# SOCAMES 6 Design Alert 1

## HEFP SEP (SOCAMES 6) Design Alert 2

Below is a diagram of an example demonstrating the use of the estimation tool.

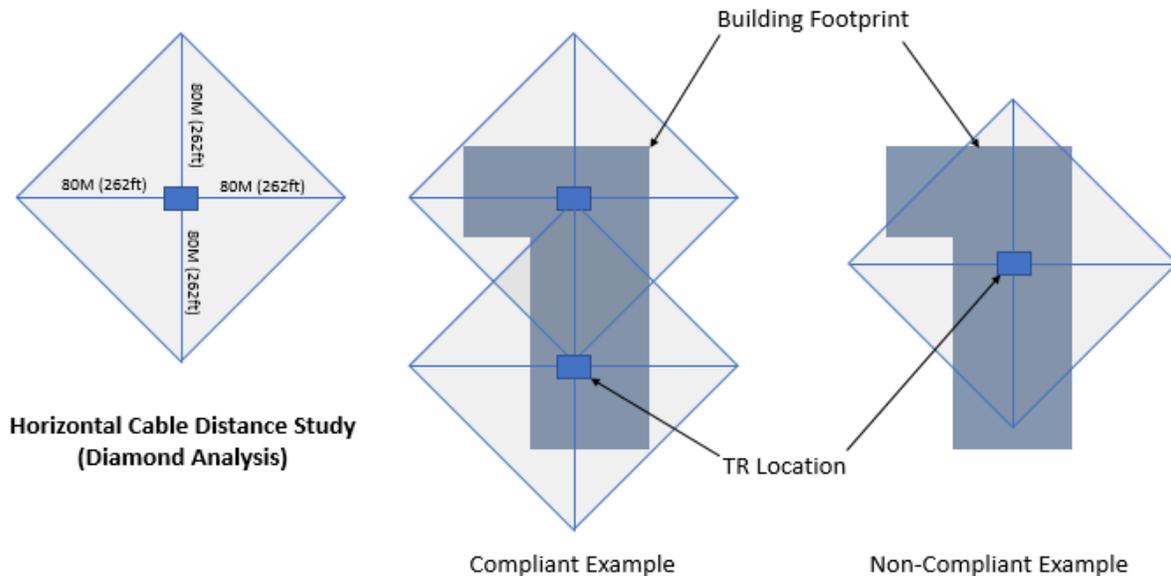
**Step 2:** Utilizing AutoCAD or rule, center on the location of the telecommunication room being assessed. From the center of the room project out lines, 80 meters in length from that point, in the plan north, south, east and west respectively.

**Step 3:** At the end each of the 80 meters lines created, connect a line 45 degrees from that point out to the next end point creating a diamond.

**Step 4:** Validate that all areas served by that telecommunication room fall within the parameters of the diamond overlay.

Since it is necessary to account for vertical cable distance, installation of slack for bypassing obstructions, cable management, bend radii and other in-situ obstacles 80 meters is utilized instead of the 90 meters acceptable length. This is to provide a realistic estimation of coverage of the representative telecommunication room.

- B. Facility shall have end-to-end, geographically diverse and carrier-diverse circuits with minimum fiber pathways separation: service provider public rights-of-way 75 ft, Egress 20 ft, and cabinet 10 ft. See below Figure 1.

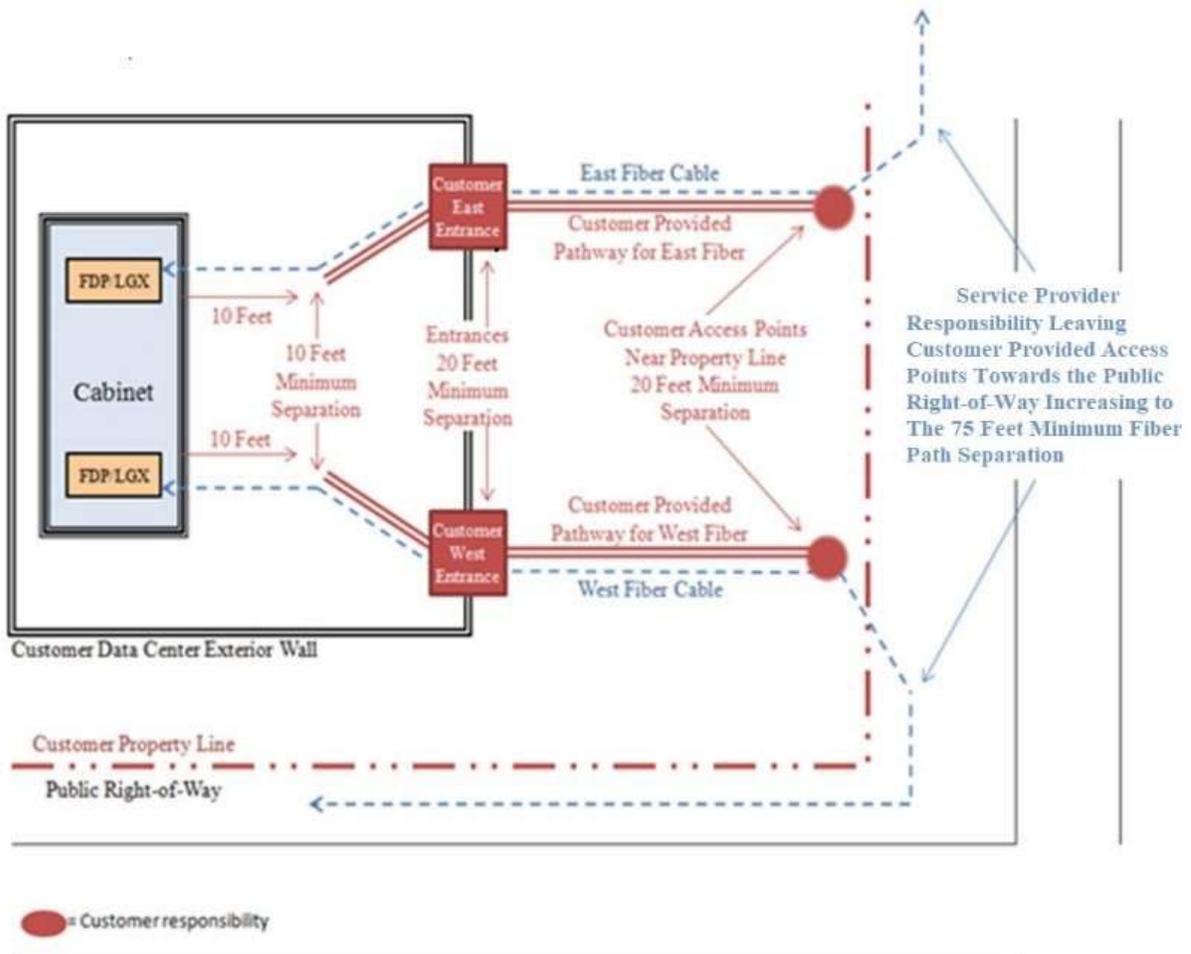
HEFP SEP is working with OIT to create a process for installation of the additional geographically diverse path for the Wide Area Network (WAN) to ensure compliance with the VA OERHM Site Infrastructure Requirements (SIEUDR), version 2.0, paragraph 2.1.1.2.B (see below). However, HEFP SEP determined that there is currently no national OIT or OEHRM process to coordinate this work with the OIT contracted providers.

To prevent delay and ambiguity in meeting this requirement, if a VAMC is unable to identify or locate the boundary entrance point, HEFP SEP recommends that the site discontinue this effort in current EHRM NRM projects and de-scope this work from the design and/or construction contracts (whichever applies). At this time, HEFP SEP will not provide updated IGCEs, but VAMCs may adjust cost estimates, as they find appropriate.
